**ALA WAI CANAL FLOOD RISK MANAGEMENT STUDY
O'AHU, HAWAI'I**

**APPENDIX H
VALUE ENGINEERING STUDY**

VALUE ENGINEERING STUDY SUMMARY REPORT
Prepared for US Army Corps of Engineers

Value Engineering Report
May 15, 2016

Drawing No. 2

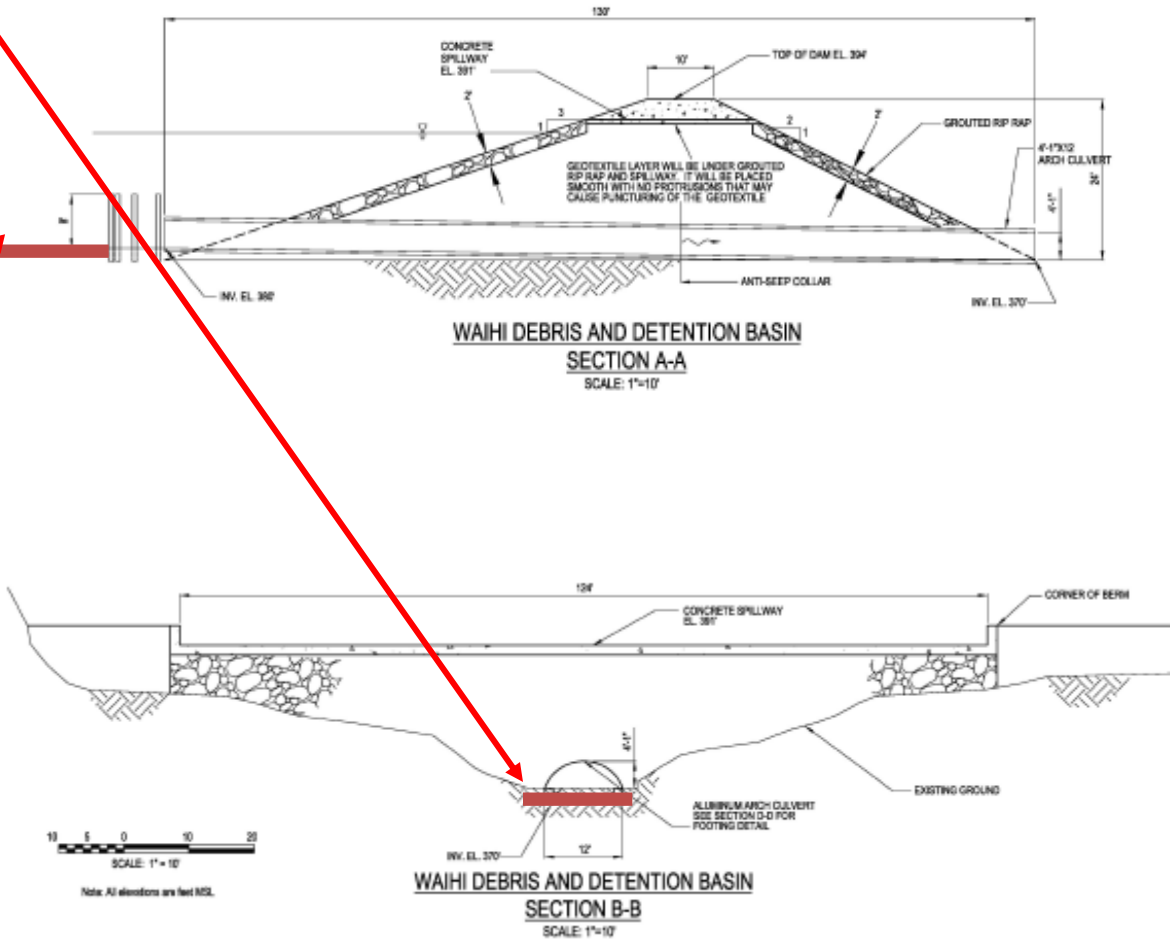
DESCRIPTION: Provide concrete pad in the detention basin for O&M cleaning.

Original design does not have a concrete pad for equipment access.

Add a 20 ft X 20 ft wide concrete pad adjacent to the debris catching post.

1. Disrupts low flow natural channel for fish passage by hardening the area near the basin.
2. Additional de-watering in the area to form and pour the concrete slab.
3. Could increase stream velocity in the location.

Drawing No. 1

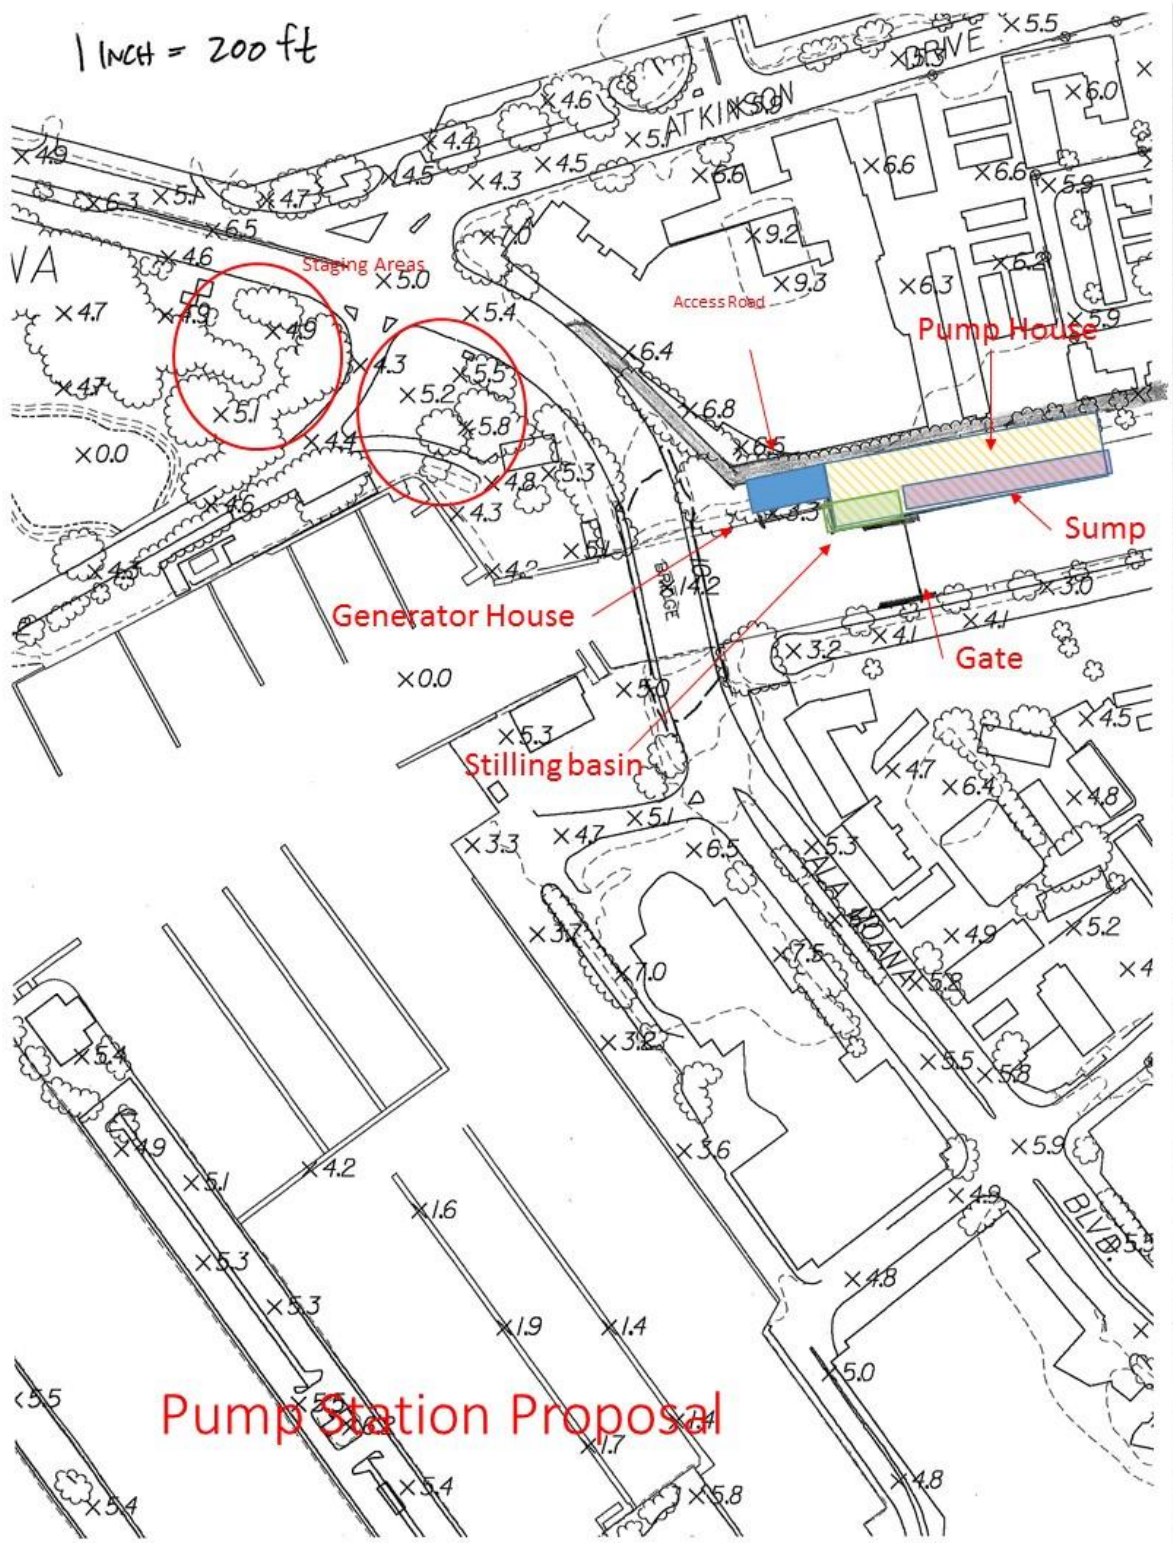
DESCRIPTION: Provide pump station at Ala Wai canal exit to ocean

PROPOSED DESIGN: In addition to a flood gate (proposal #3), a pump station will be constructed and used in combination with the gate to provide flood risk management. The flood or tidal gate design would consist of a miter gate to cover a 120 ft wide opening built across the canal mouth 300 ft upstream from the Ala Moana Blvd Bridge. The miter gate would consist of 2-65 ft wide by 15 ft tall steel gates with concrete footing at invert -10 ft and top of gate at +5 ft elevation. The side structure on the left bank would be built with not more than 5 ft protruding into the canal (canal is 160 ft wide) while the right bank side structure would be built as part of the pump house sump and stilling basin. Assume the side walls (monoliths) would be 5 foot thick and the foundation slab to be 8 foot thick reinforced concrete. Bottom foundation would be 140 ft by 80 ft in size. Side walls would be 80 ft by 15 ft. The pump house design would be a pump house 400 ft long by 100 ft wide (of which 40 ft extends over/into the canal) with a roof line about 40 ft tall. The pump house would contain 10 pumps each 96-inch axial flow 800hp pumps (MWI pumps model no. NC396P37) plus sump, stilling basin, and other operating equipment. The sump would be located on the upstream end of the pump house upstream of the gate and be built in the canal, about 300 ft long by 40 ft wide, form the footing of the pump house over the canal, and have an invert elevation of -20 ft. Assume the entire sump to be built of reinforced concrete 3 ft thick with steel grates spaced throughout the walls on the canal sides. The stilling basin would be located on the downstream end of the pump house downstream of the gate and be about 100 by 40 ft, invert of -10 ft, about 120 linear ft of reinforced concrete wall 3 ft thick, also with steel grates spaced throughout the walls on the canal sides. The purpose of the stilling basin would be to help reduce turbulence from the pump outtake lines and along with the about 300 ft distance upstream from the Ala Wai Yacht Harbor, have a minimal impact to wave action in the harbor caused by the pumping activity. Next to the pump house, would be a 60 ft by 100 ft back-up generator house (if needed; it may all fit into the pump house). Access road, 15 ft wide, would be from Ala Moana Blvd and from Kalakaua Ave using the existing canal promenade walkway. There is a 75 ft wide access along the right bank (the promenade walkway width between canal and property boundary with Yacht Harbor Towers) and 50 ft wide access on the left bank using the Ala Wai Blvd road. Staging area to use park land at Ala Moana Beach Park. Promenade pedestrian access can be blocked during construction but access along Ala Wai Blvd to Harbor View Plaza building must be maintained.

1. Changes the canal ecosystem during large storm events. By shutting out tidal influence and pumping out canal and then having canal fill with flood runoff (freshwater) before mixing again with ocean water when gates are opened would result in killing of fish species. Although most fish and other aquatic species in canal are mostly invasive species, the rapid mixing of ocean and freshwater would create ecosystem havoc. Some floating runoff debris and dead fish would be released into the small boat harbor even with floating trash boom in place. The rapid mixing would also result in density currents mobilizing bottom sediments into and out of the canal. These sediments could have an impact to the yacht harbor and near ocean environment.

2. Location of pump house near residential apartments (Yacht Harbor Towers) would result in noise issues to residents when pumps are running. Noise abatement in structure is needed.

Drawing No. 2

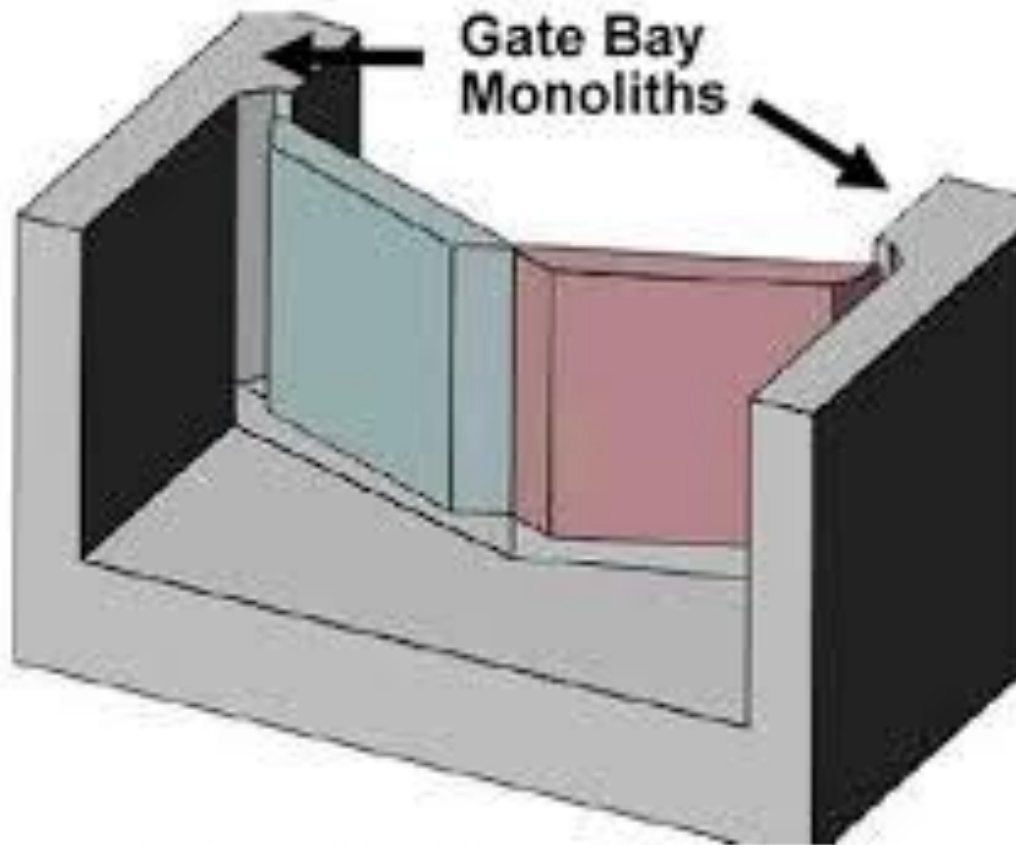
Miter Gate Drawing

A variant to this design is to use sluice gates instead of miter gates. This would require at least one sluice gate to be 30 feet wide to allow for boat and dredging barge passage. Sluice gates would rise above canal when open and be very tall, sticking at least 16 feet high above the canal, creating a much bigger view-plane problem.

Drop gates, like the London Flood Barrier, could also be used. These gates would rise up from the bottom of the canal when closed.

Results from simulation run with pumps (10 - 96-inch pumps) and 7 ft gate opening

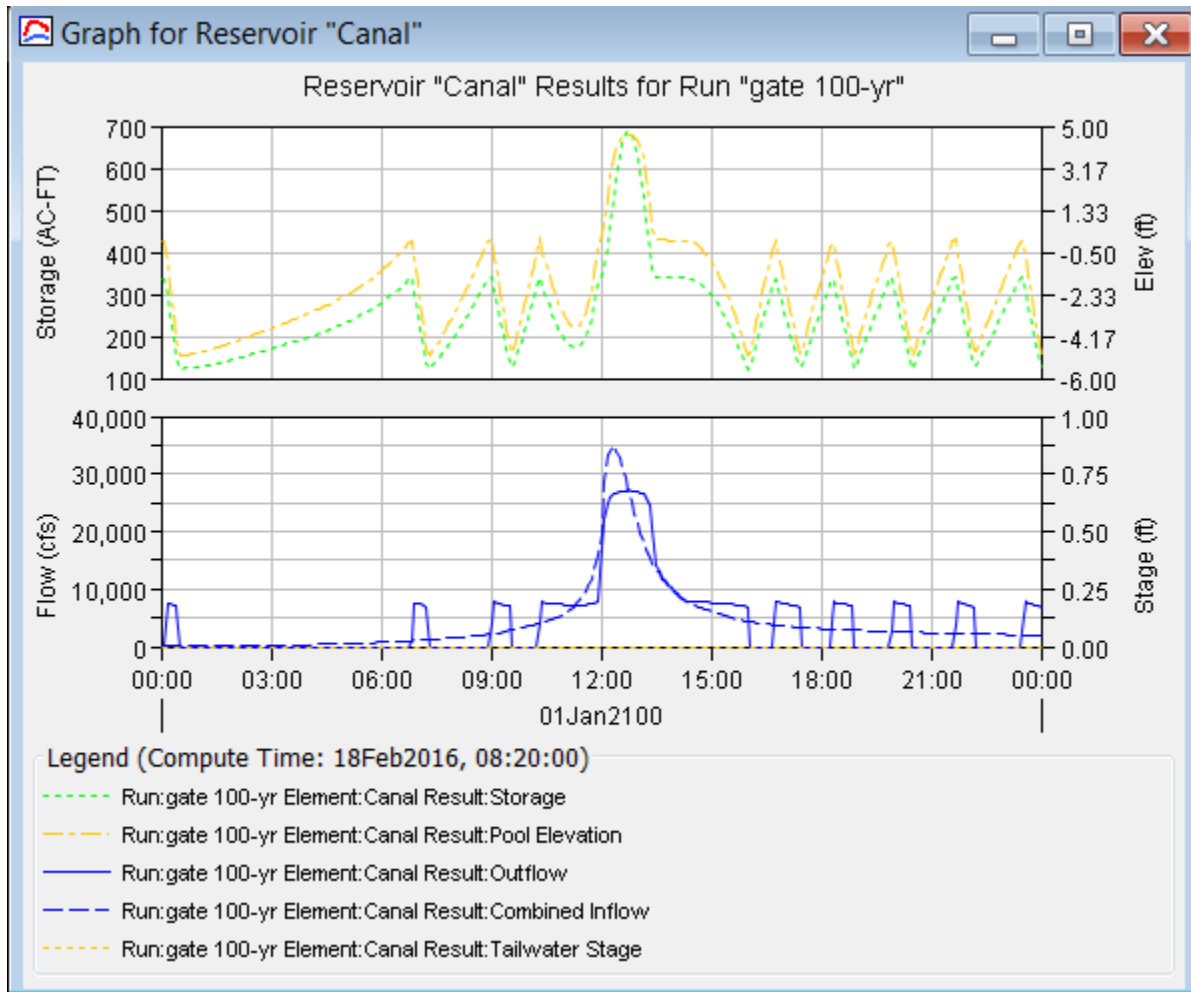
To determine number of pumps, the HEC-HMS model for the Ala Wai canal project was changed to add the gate and pump features. The existing without project model treated the canal as a reservoir with discharge outlet to the ocean treated as a 14 ft by 152 ft culvert opening. The existing without project model results for the 1% ACE flood event had a peak stage of 6.4 feet which is based on the canal storage volume curve. The limitations of the HEC-HMS model allows for only a simple analysis of this proposal alternative. For example, gates cannot be opened during a simulation run, they are closed and remain closed or are open and remain open through the simulation. Pumps are controlled by the on and off stages. The maximum number of pumps is 10.

Results from pumping alone, with no gate opening during the 1% ACE flood event would result in a peak stage of 8.0 ft. Thus, pumping alone without gate control would result in the need for floodwalls along the canal to be 4 to 5 ft high on average. The same floodwall heights as in the current TSP.

Results from pumping and with a gate opening of 7 ft resulted in a 1% ACE flood event peak stage of 4.6 ft. This would result in minimum residual damage along the canal. The existing right bank elevations vary from 3.5 ft along the Golf Course banks to 5 feet, while the left bank elevations vary from 4 to 5 ft. Thus, any peak stage below 5 feet is considered adequate for this proposal in showing that the propose solution would work. The 7 ft gate opening represents half the maximum opening size. The gate was modeled as sluice gates in HMS.

Drawing No. 1

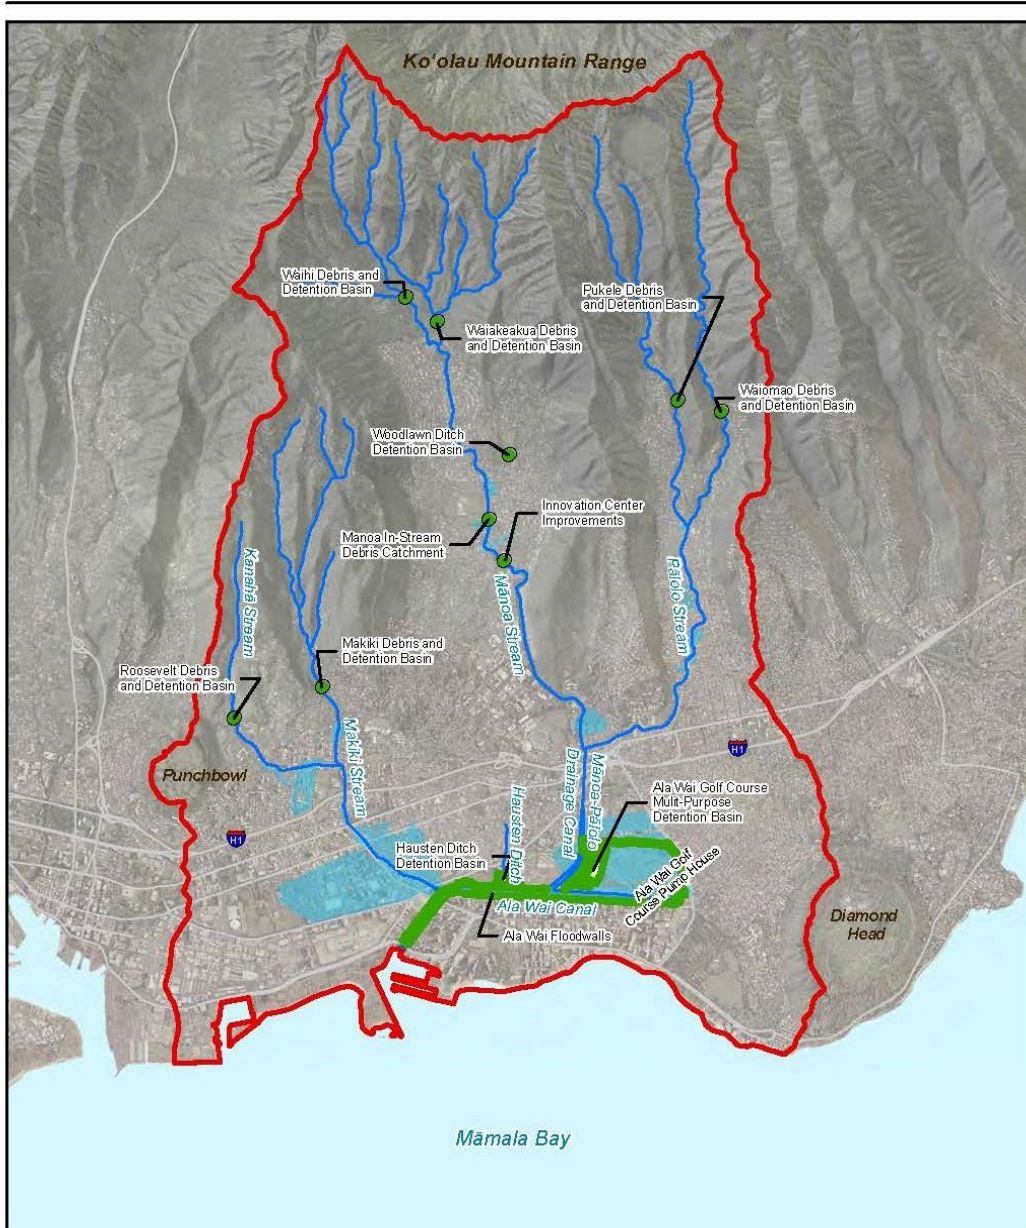
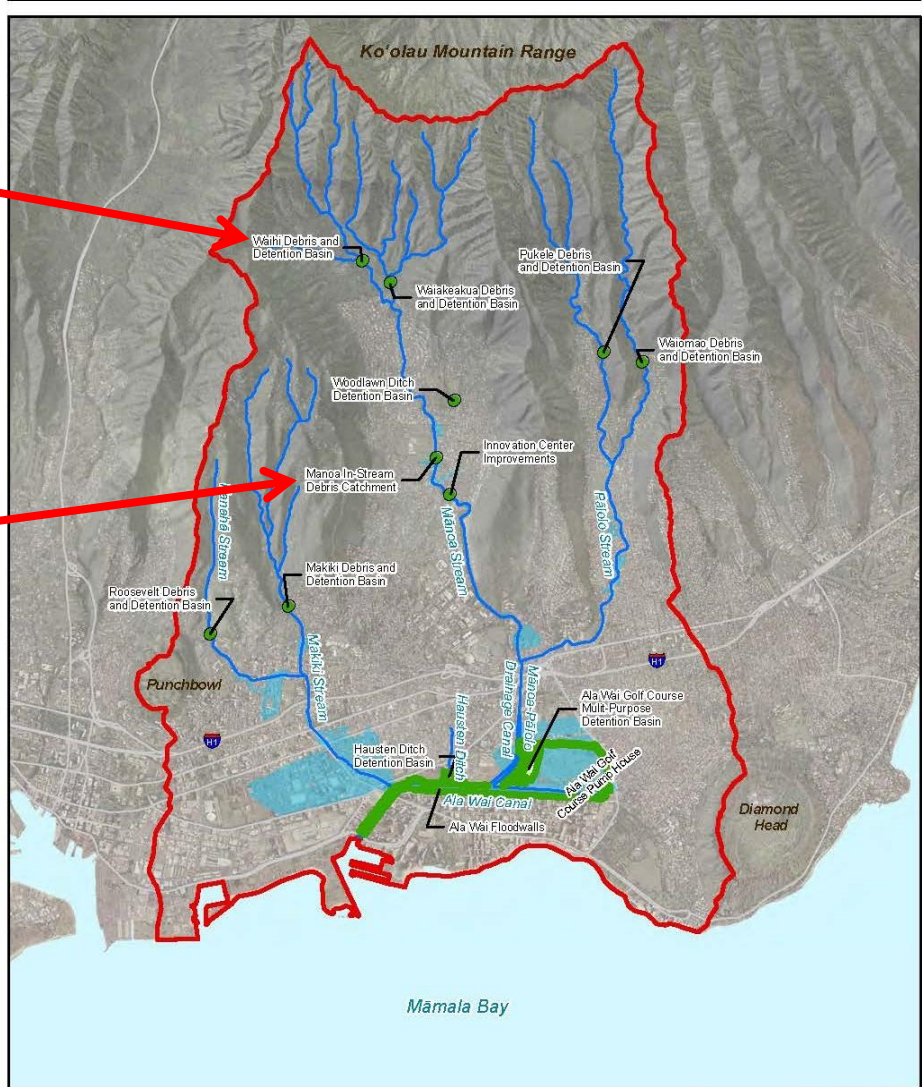
DESCRIPTION: Revisit using Manoa Park as a multipurpose site for debris catchment and detention

PROPOSED DESIGN: Integrate Manoa Park in lieu of utilizing either Waihi or Waiakeakua basins.

Remove Detention Basin

Replace Debris Catchment With Detention Basin

Drawing No. 2

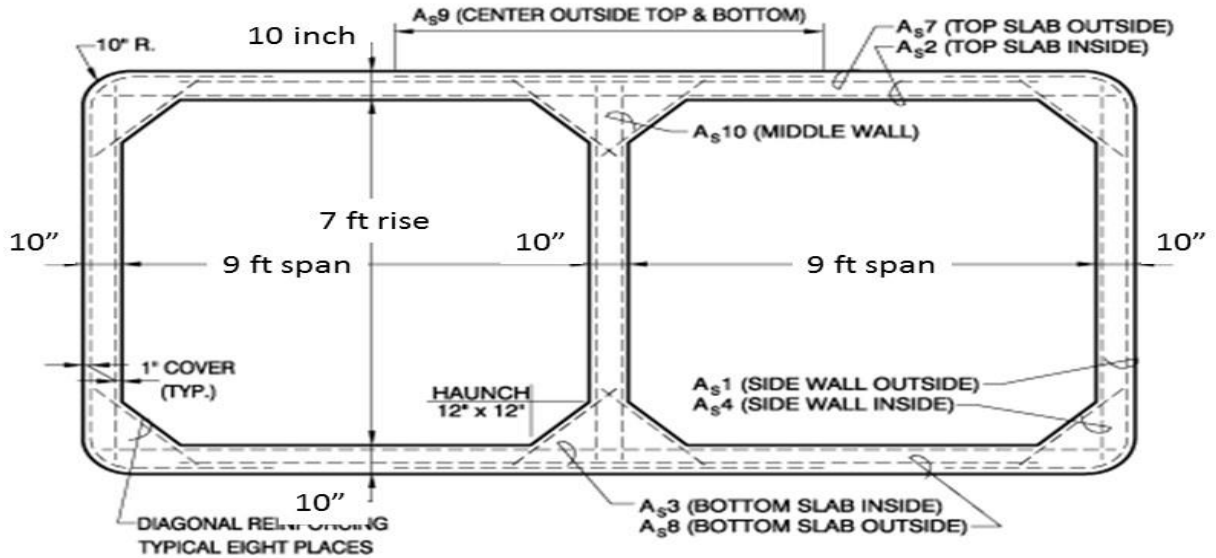
DESCRIPTION: Delete either Pump Station 1 or Pump Station 2 and use one pump station to handle both drainage areas

PROPOSED DESIGN: Based on the invert elevations, the stormdrains from Pump Station 1 will be routed to Pump Station 2. Pump station 2 will be enlarged to handle the combined flow and Pump station 1 will be eliminated from the alternative. The new stormdrain connection will only have capacity for the 2% ACE event of 880 cfs, slightly higher than 10% ACE design flow due to tailwater conditions. Given that the invert is below sea level and using a 0 ft mean sea level elevation and a drop of 0.6 ft over 720 ft for slope of 0.0008 creates a 17 ft wide by 7 ft deep reinforced concrete box culvert about 720 ft long with two new manhole chambers/structures, at the initial connection to the existing 12 ft by 7 ft box and at the 9 ft by 6 ft box connection, will be needed. The new 17 ft by 7 ft box will terminate into the sump at Pump Station 2. Structural or geotechnical considerations may require that this new box culvert be built as two 9 ft by 7 ft box culverts. For the purposes of this proposal, assume two 9 ft by 7 ft boxes with 10-inch thick slabs/walls and less than 2 ft of earth cover on top. Construction will assume digging in coral and fill material and dewatering will be required. Pump Station 2 will be enlarged to have four pumps (Sheet A-302 is original design with three pumps). It is assumed that this additional pump is all that is needed for the extra flow being diverted to this location. This assumption is based on the coincidence of stormdrain flows entering the sump won't occur at the same time from all stormdrains now entering this pump station and that pump and gate operations will be optimized to allow for the smallest pump station needed. This will increase pump station size to about 130 ft by 70 ft. The existing outlets for the 12 ft by 7 ft box and 9 ft by 6 ft box will remain and have sluice gates as per the original plan. These gates along with the gate structure at Pump Station 2 are part of the optimized gate operations.
